MEMORANDUM

TO: District of Columbia Zoning Commission
FROM: ^{JLS} Jennifer Steingasser, AICP, Deputy Director, Development Review and Historic Preservation
 Karen Thomas, Development Review Specialist
DATE: November 7, 2022
SUBJECT: Supplemental Report for Zoning Commission Case No. 22-11, Consolidated Planned Unit Development and Related Map Amendment from MU-12 to MU-10 at 807 Maine Avenue, S.W. / Square 439-2, Lot 15

A: Ground Floor Comparison

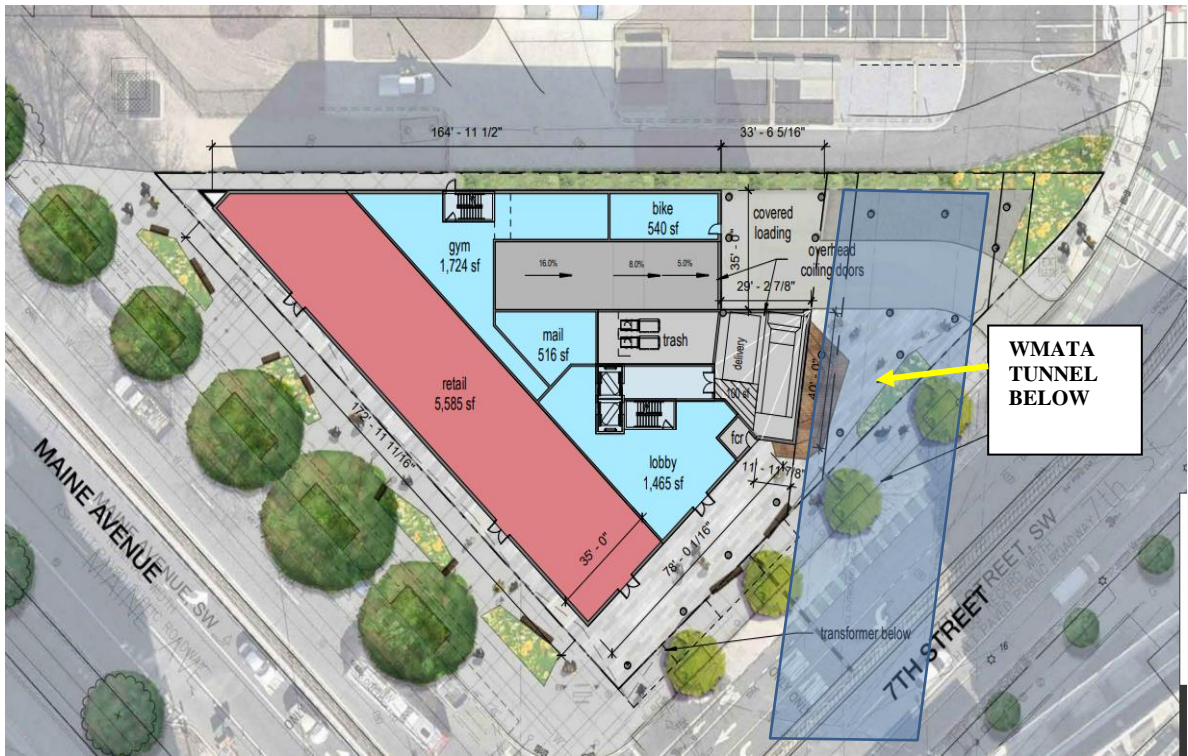
Comment	Applicant Response	OP Analysis
	<u>Revisions</u>		
ZC	The building’s design should be reviewed – including its density, lot occupancy and gross floor area	<p>The design was revised accordingly:</p> <ol style="list-style-type: none"> 1. <u>Decrease in density</u> overall from 8.64 to 8.21 with the GFA reduced from 204,459 sf to 194,839 sf. The density was removed primarily from the northeast corner of the site and replaced with sustainable landscaping accessible to the public. 2. <u>Ground floor retail</u> converted to residential use. 3. <u>A decrease</u> in lot occupancy from 90.78% to 82%. 4. <u>Decrease</u> in number of units from 202 to 195 <p>See Exhibits 69A1, 69A2, 69A3 for a comprehensive view of the revised plans.</p>	<p>OP supports these revisions for the reasons stated by the Applicant to address the “bulk” concerns by both the ZC and the community. While there are site encumbrances due to the WMATA easement, the building’s height and density presented a bulky appearance. With the revised design the Applicant was able to reduce the lot occupancy at the ground level closer to the permitted and reduce the density within limits anticipated for the PUD in the requested zone, without a significant decrease in the number of units.</p> <p>The revisions would also include accessible on-site open space, which would create a visible sense of space and place typical of SW apartment buildings, and consistent with the SW Plan’s vision. The PUD is located in a neighborhood with immediate access to amenity-rich outdoor spaces including the Wharf, and with bike access along the waterfront to river parks and outdoor/recreation spaces.</p> <p>OP supports the design changes to reduce overall density with a modest decrease in the number of units.</p>

Current Ground Floor Proposal as amended ([Exhibit 69A2 Sheet 31](#))
